APPLICATION FOR CONDITIONAL USE PERMIT

Case No. 1989-14-CUP

HENRY AFRICA'S
DECK & BEACH ADDITION

SITE PLAN REVIEW

SITE PLAN

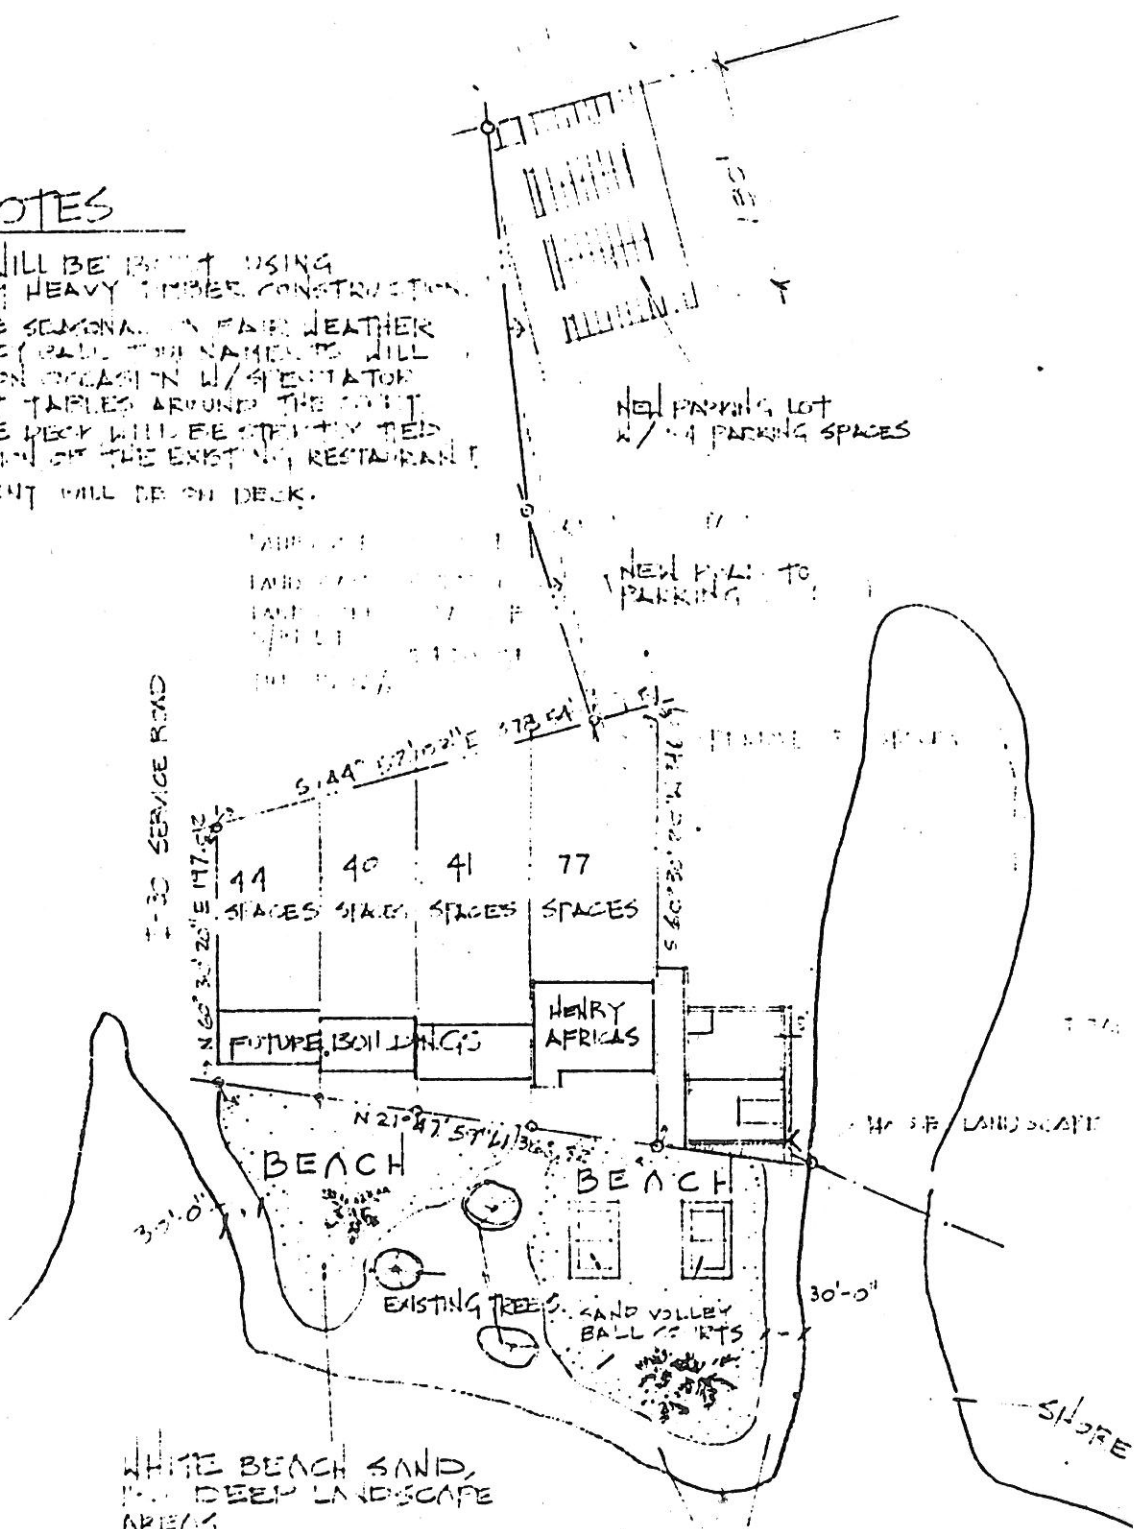
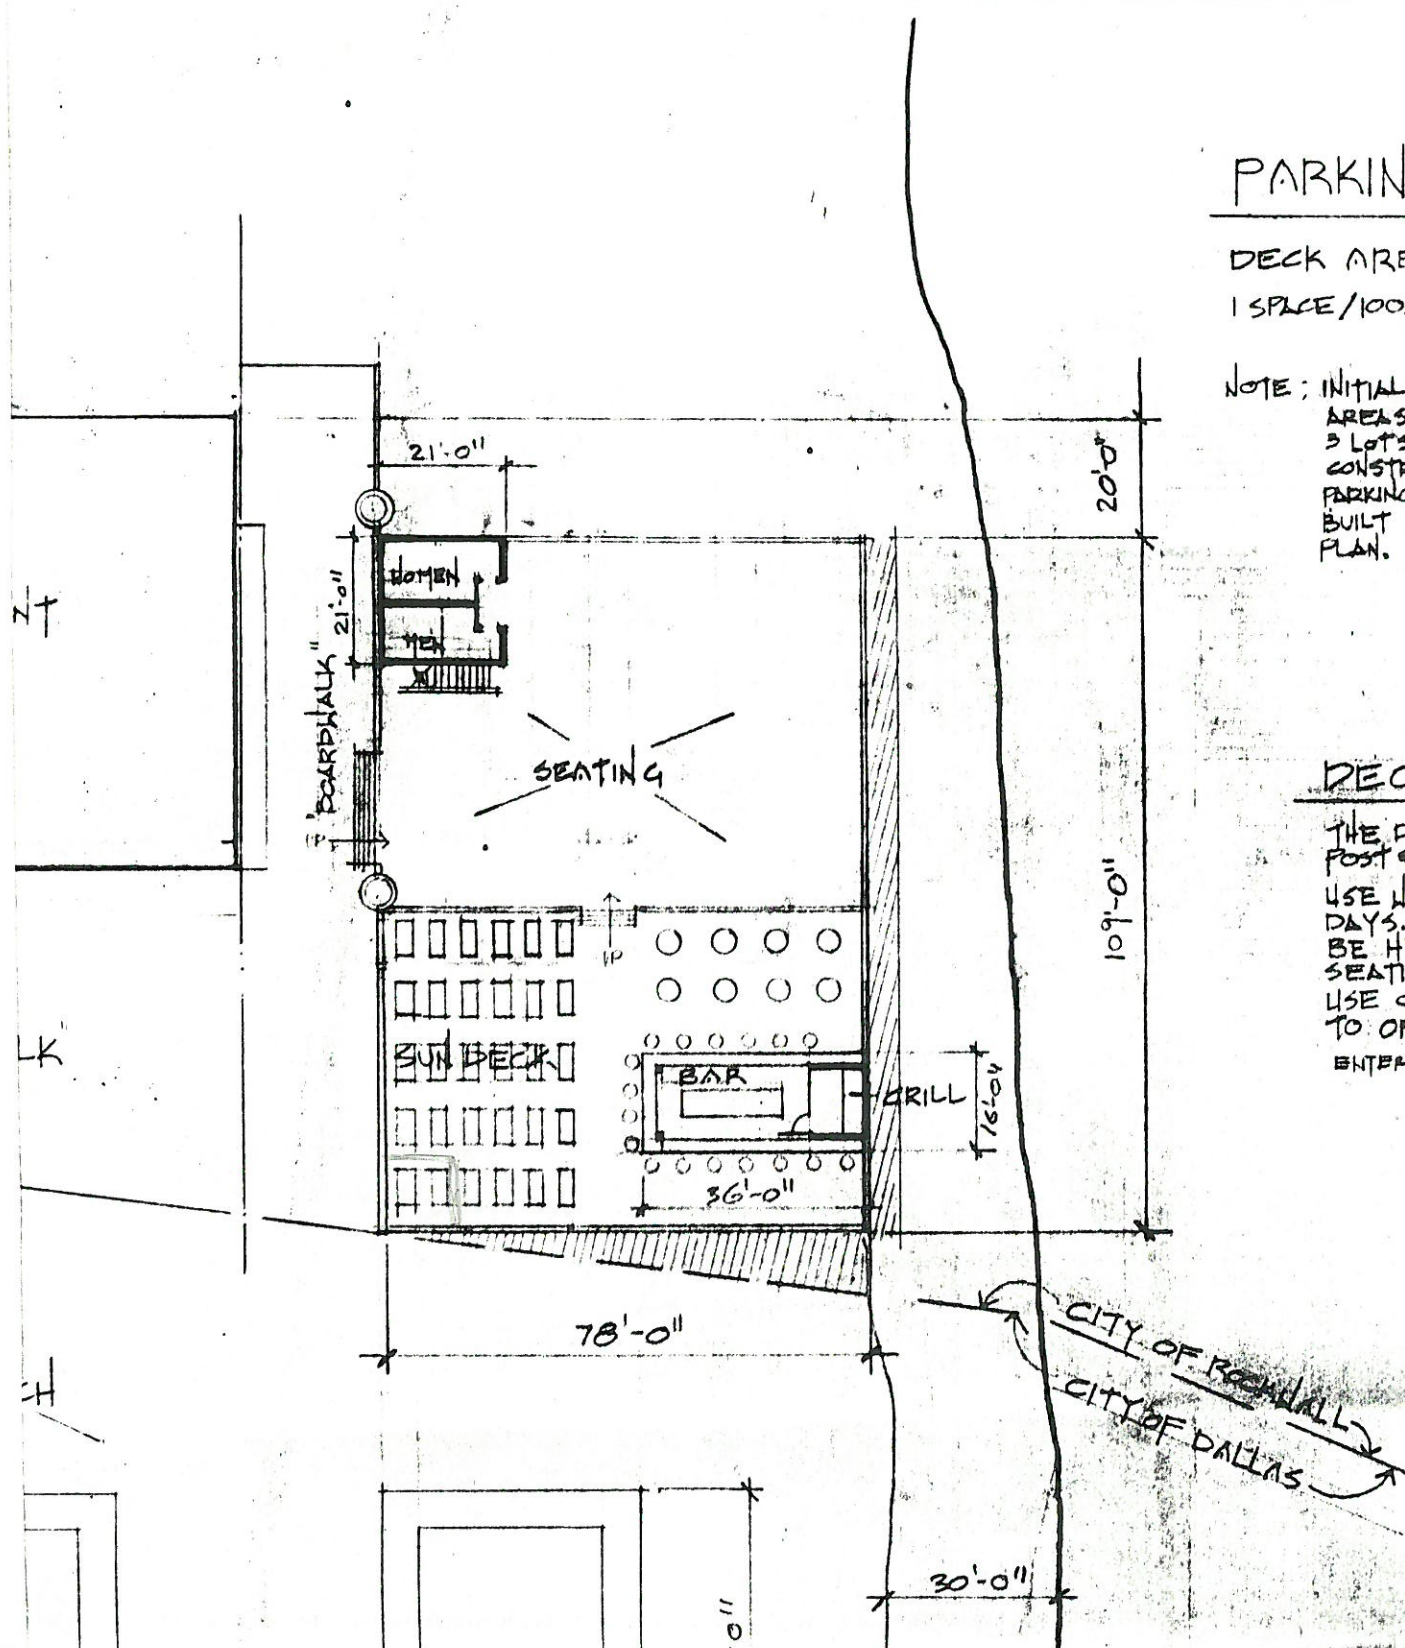
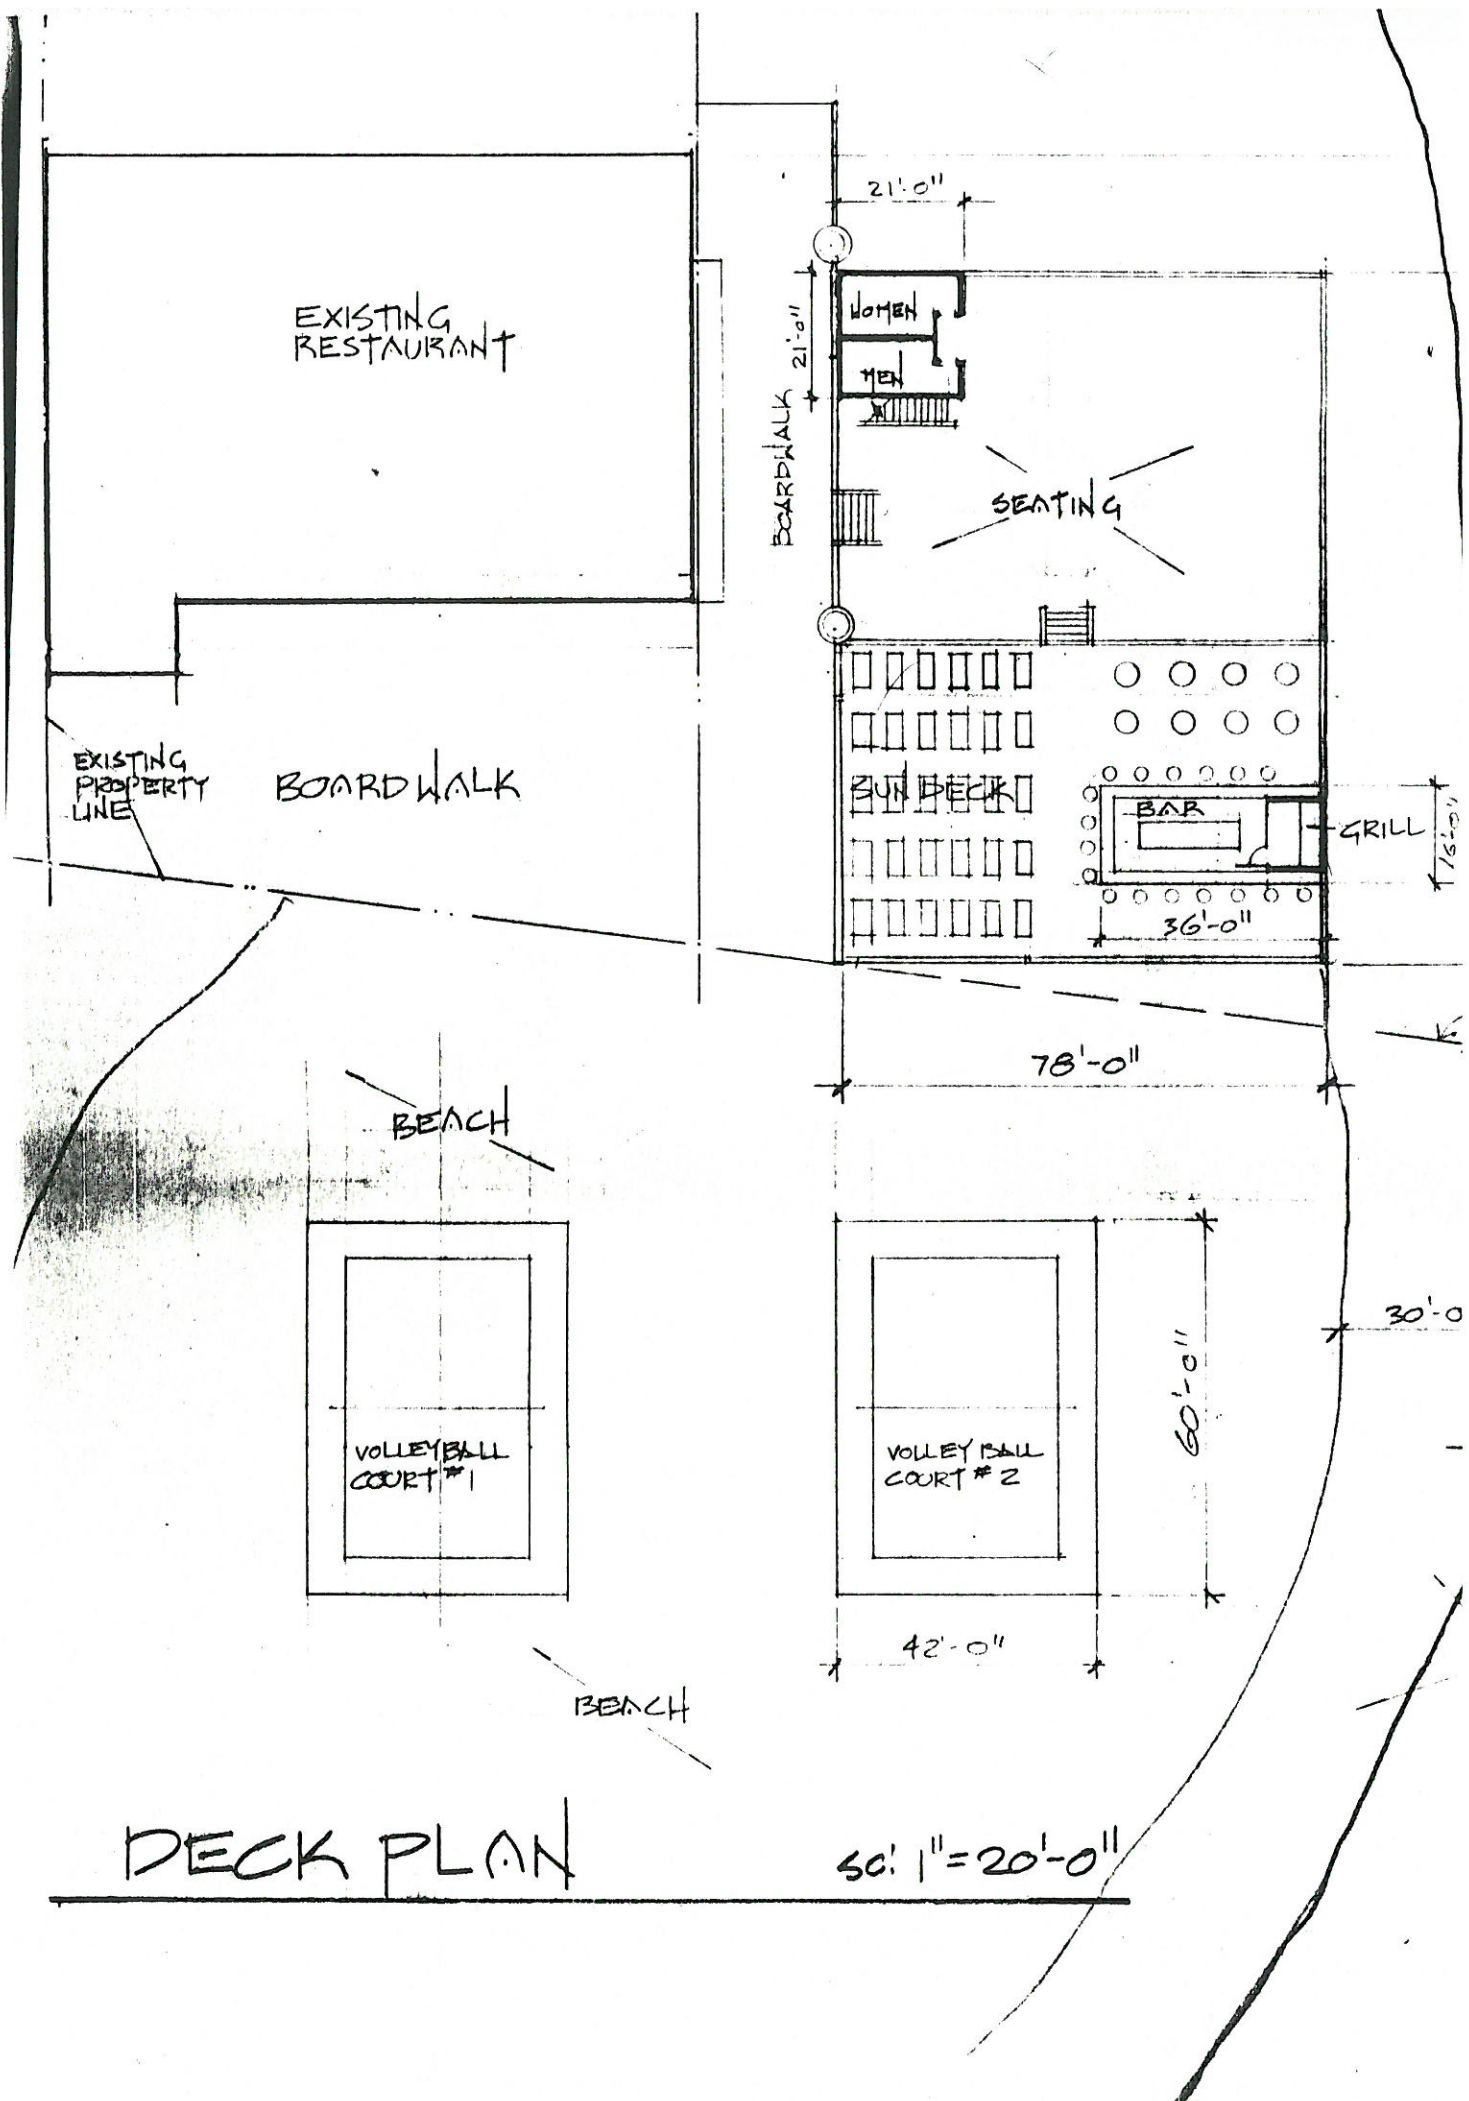
1. With the addition of the deck area the required landscaping would increase by 11,088 sq. ft. The minimum landscaping for that area would be 15% or 1,664 sq. ft. The only area that would be available for landscaping would be along the inlet. This is planned at some future time to be used as a docking area to provide boat access to the development. It is also going to be approximately 4-5 feet below the deck when it is constructed. The applicant has been asked to address the issue of landscaping this area. They may request a waiver to those requirements. In light of the location of this deck with the proximity of the take line and the improvements that will be placed there, and due to the height of the deck additional landscaping would probably not enhance this area significantly. We will hear from the applicant Thursday night regarding this matter.

2. The parking will have to be increased to 75 spaces in order to meet the standard parking requirements. The parking will be installed at the time of construction of the deck.

3. They are proposing to place the required parking for the deck in the eastern part of PD-7 as shown on the site plan. The drive for this new parking needs to be realigned to tie into the site plan for Henry Africa. The landscaping ordinance requires that a parking lot with more than two rows of parking to have internal landscaping. We have asked them to provide the area within the parking lot. Again, they may request a delay from the landscaping requirements for the parking lot until their development reaches this area. They will address this Thursday night.

4. The applicant plans to utilize wood that has been salvaged from another building for the deck. If the wood meets the building code structural requirements it could be used, however if it cannot be rated it cannot be used.

5. There has been no indication by the applicant that they would want to be able to have entertainment on the deck such as bands or dancing, etc. We have requested them to indicate what, if any, entertainment they might want to utilize on the deck. The Commission may want to consider a condition in the permit regarding the provision of entertainment. We have in the past had some noise complaints from Lakeside Village regarding the bands at Culpepper's.

1. That the additional landscaping on Lot 4 be approved as submitted with the stipulation that a minimum of 2 trees be planted in the ground within the deck area. The location of the trees would be decided by the applicant.

2. That the landscaping and parking materials requirements for the additional parking and drive be temporarily waived for a period of two years or the construction of Phase 2 of the Harbor development, whichever comes first. The temporary parking lot and drive will be constructed of a compacted rock base with a seal coat surface.

3. That adequate lighting will be provided for the additional parking area.
4. That adequate fixtures for both the deck and for the beach use will be provided in the restrooms.

5. The entertainment on the deck is approved with the condition that the use of entertainment would be reviewed at the end of one year.
6. The plat is approved with the condition that an access easement is provided on the additional parking area.
